NL Proposal for Amending Reg 51-3 Annex 3

issued by the Netherlands
GRB 50; September 2009

ref: ECE/TRANS/WP.29/GRB/2009/4

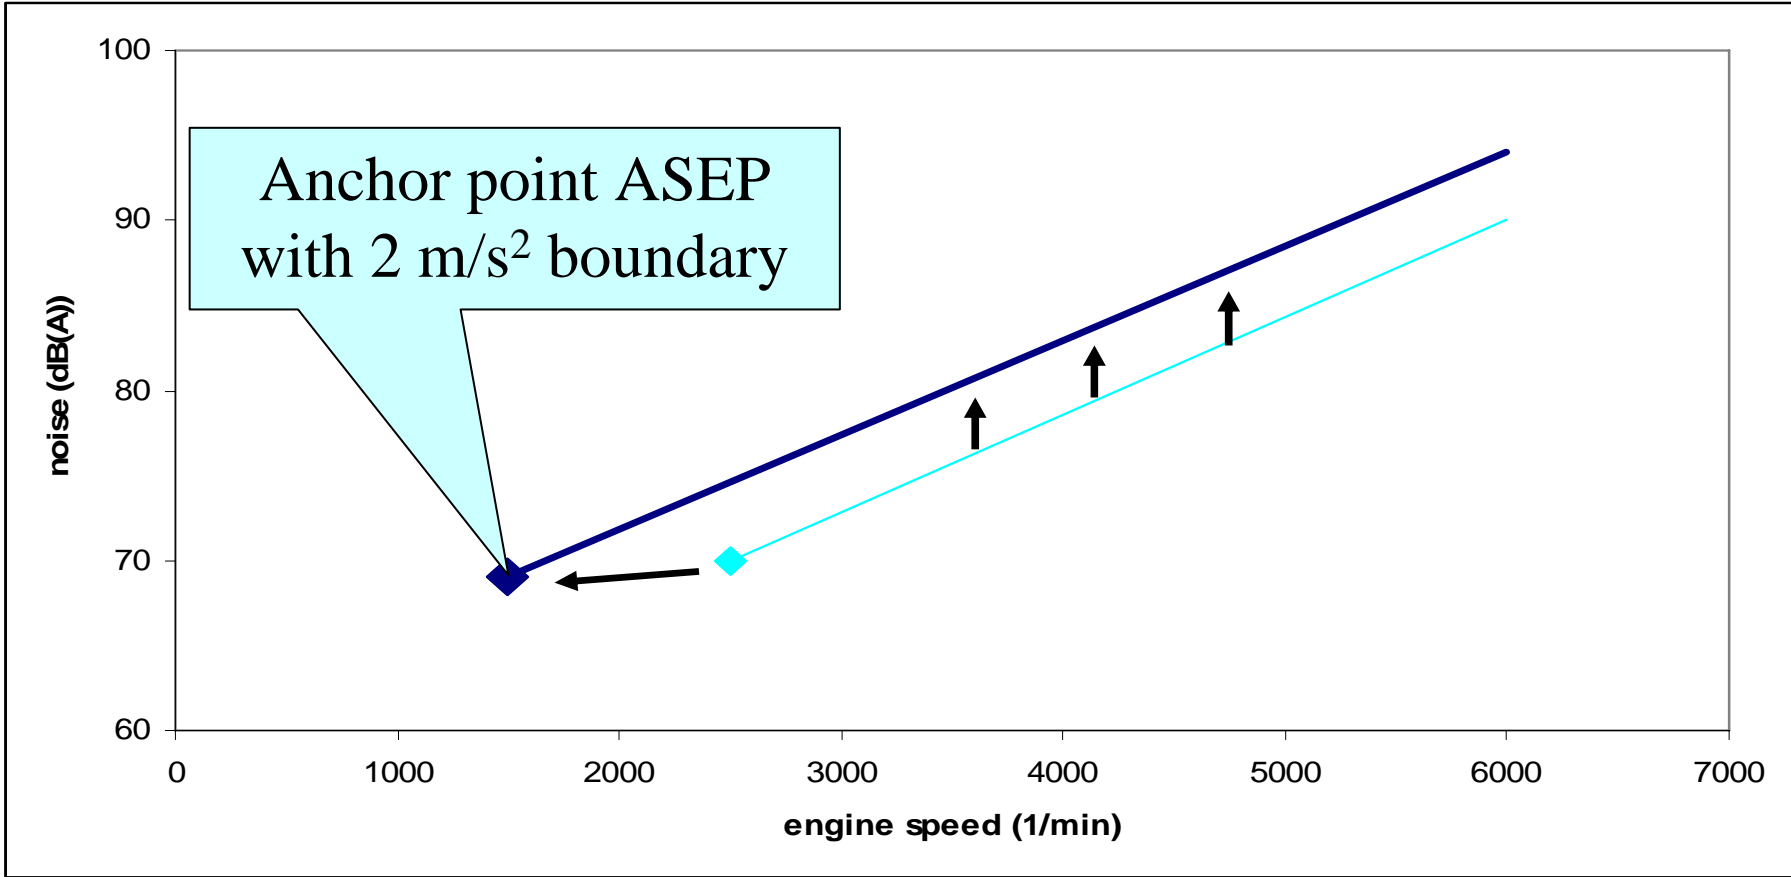
2 m/s² boundary forces vehicles to higher gears and so to low(-er) revs in the Annex 3 test situation.

Test result Annex 3 is anchor point for ASEP (revs, Lwot).

Anchor point ASEP not in balance in the middle of the map, but in the low rev area.

'Higher area' bigger → prediction less accurate

Prediction less accurate → ASEP less accurate

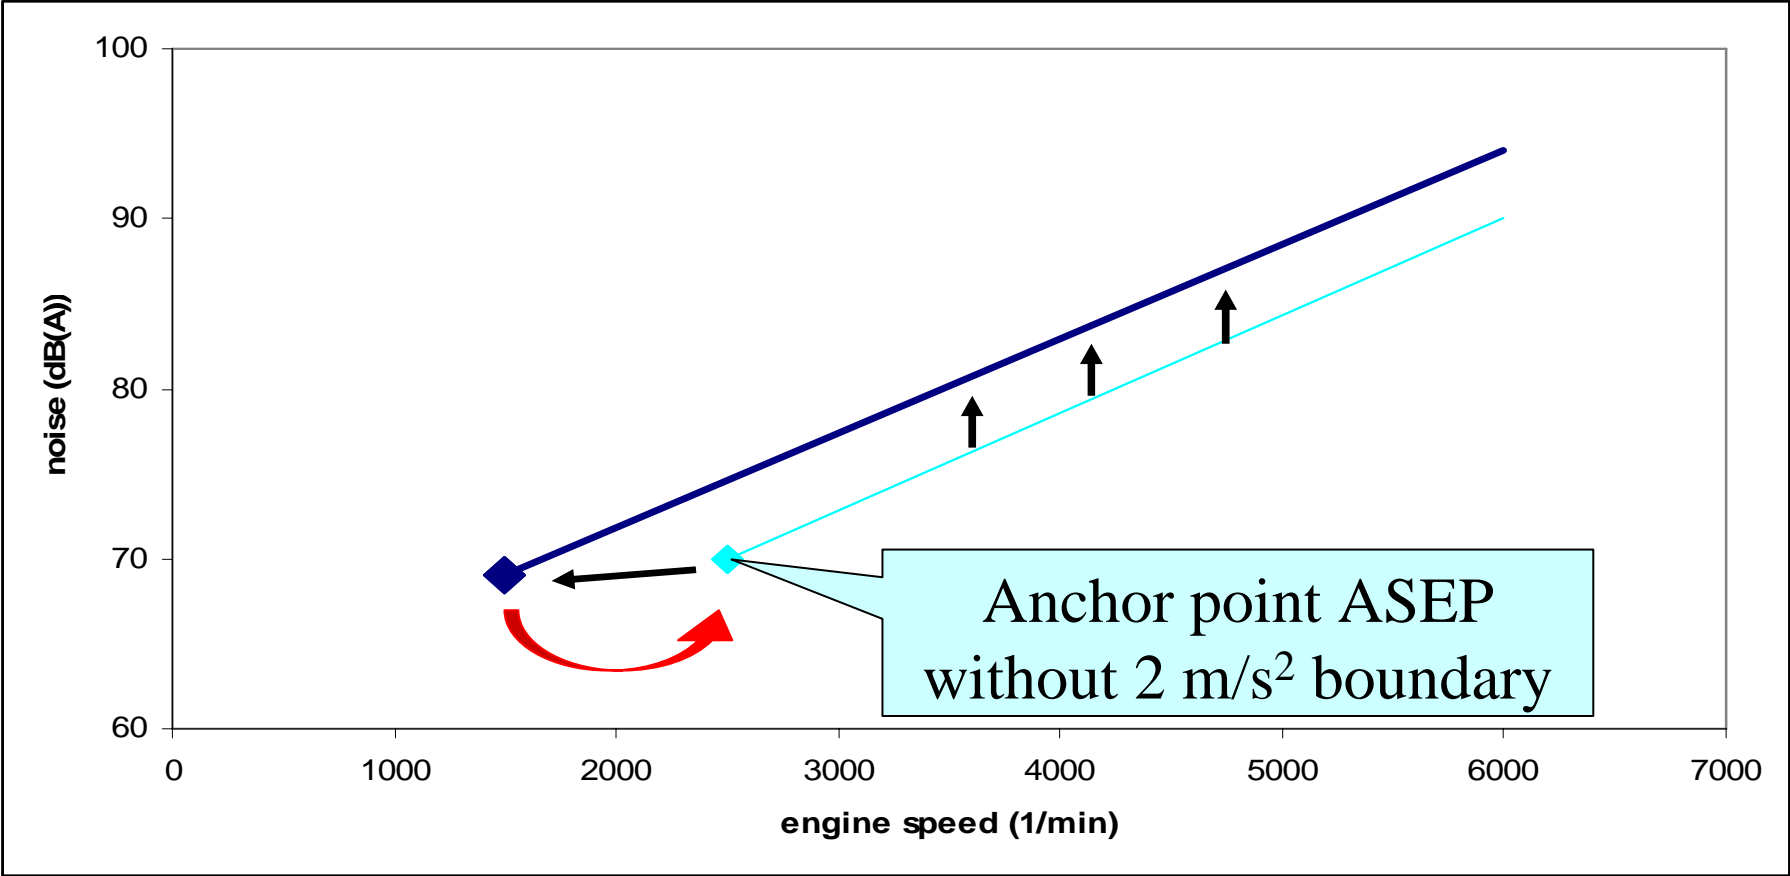
Boundary of 2 m/s² forces the ASEP limit line to the left

Intention of this proposal:
go back to the original anchor point (as based on urban statistics)
